**PLANNING & DEVELOPMENT DEPARTMENT
STAFF REPORT
NOVEMBER 9, 2021**

Application #: 2021-37
Project Name: Cider Mill Estates
Application: Preliminary Plan
Representative: Kim Kerk Land Consulting & Development
Location: 960 Stone Mountain Drive
Zone: South Fruita Residential (SFR)
Request: This is a request for approval of a Preliminary Plan for 47 single family lots on approximately 13.25 acres with a 1.29 acre park.

PROJECT: Cider Mill Estates Preliminary Plan

REVIEW COMMENTS

C1.0

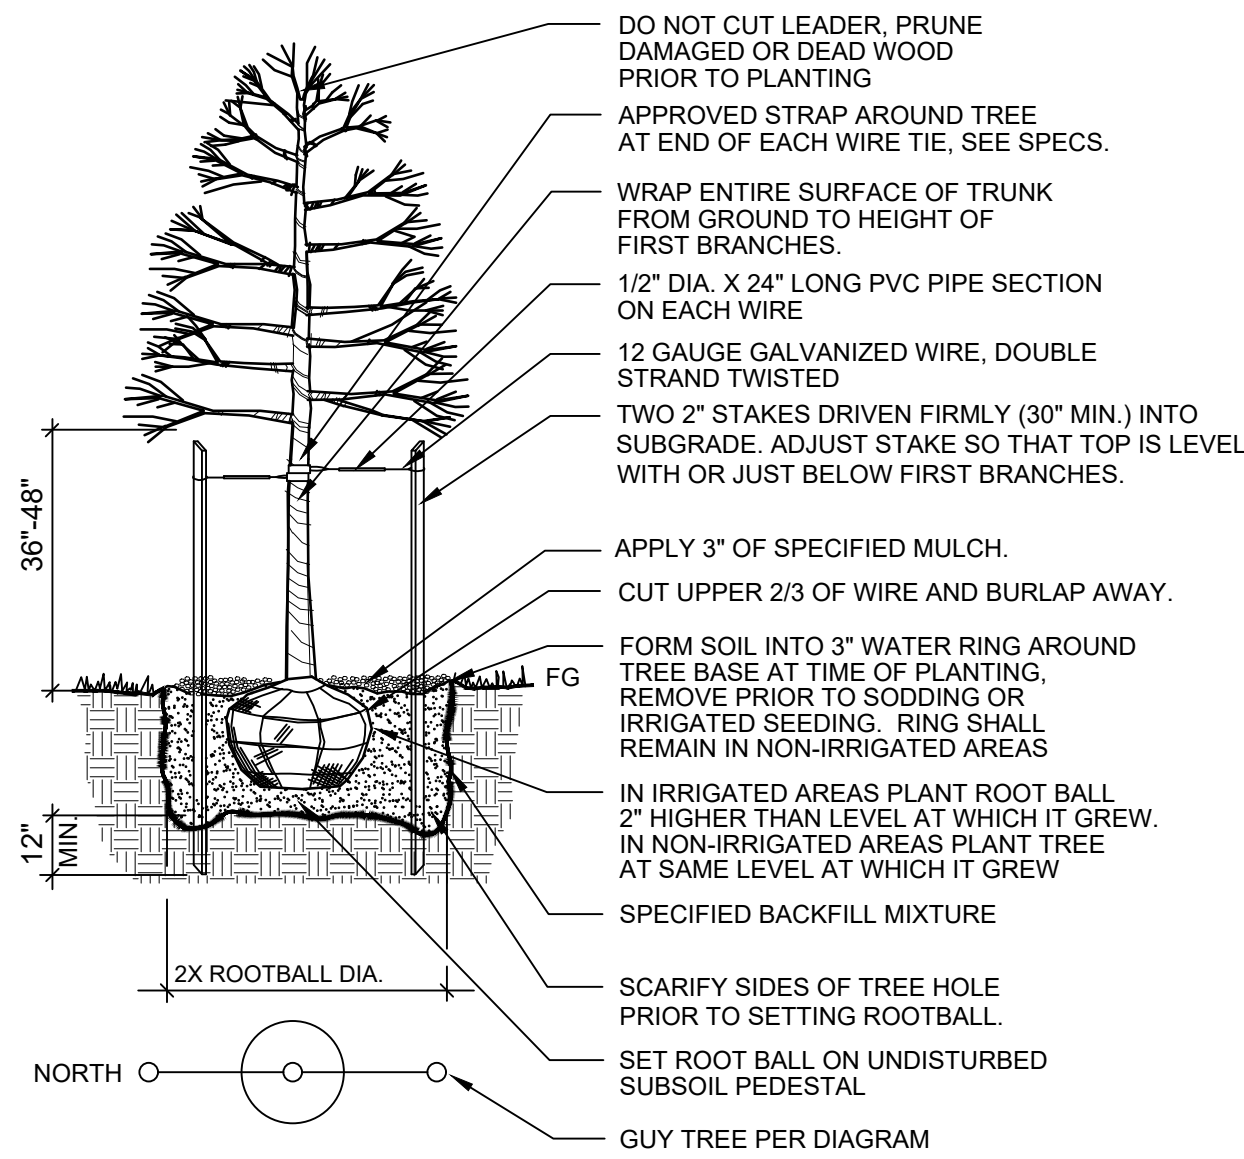
8. The park must be open to the public. This needs to be reflected on the Plat dedication language at the Final Plat application.
9. The Building Setback Dimensions on page C1.0 show a side setback of 8'. The South Fruita Residential side setbacks are 10' minimum.
